## Drainage Report

City/County File No. PPR2413

Dutch Bros Coffee (CO0907)

**PROPOSED DRAINAGE PLAN**  
5810 OMAHA BLVD  
COLORADO SPRINGS, CO 80915

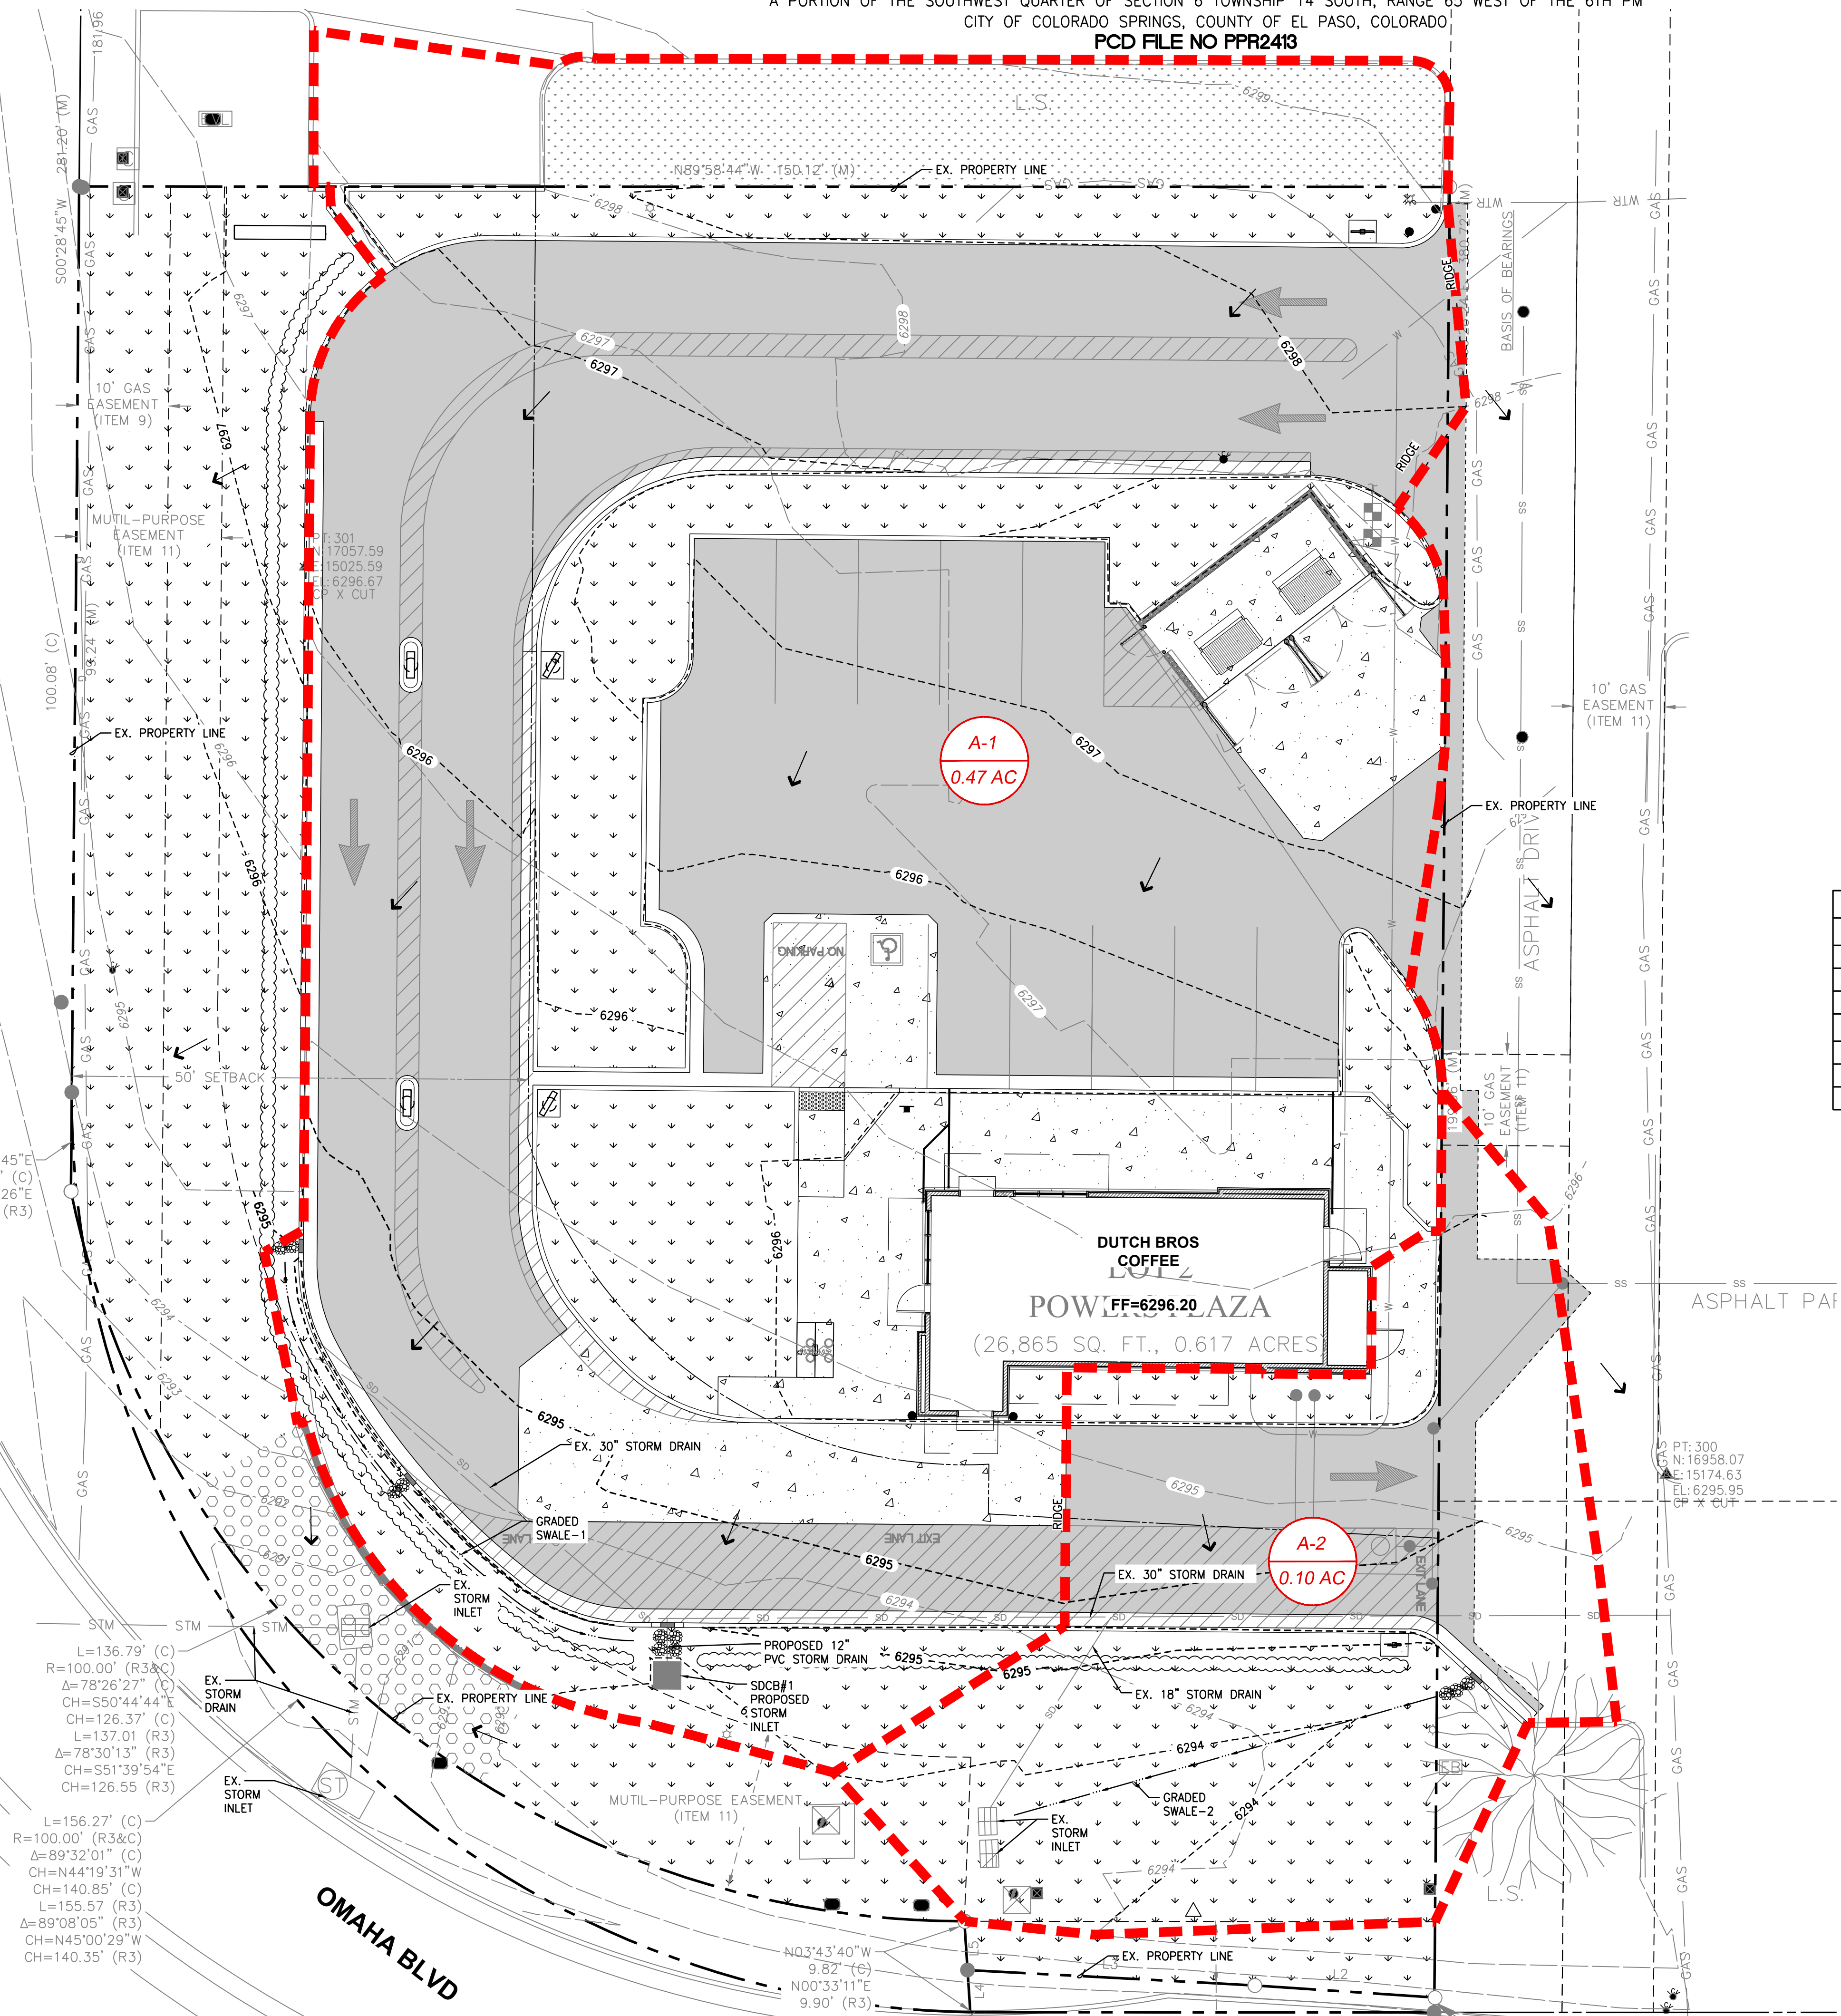
Please include the calculations for the proposed basins. They appear to be missing.
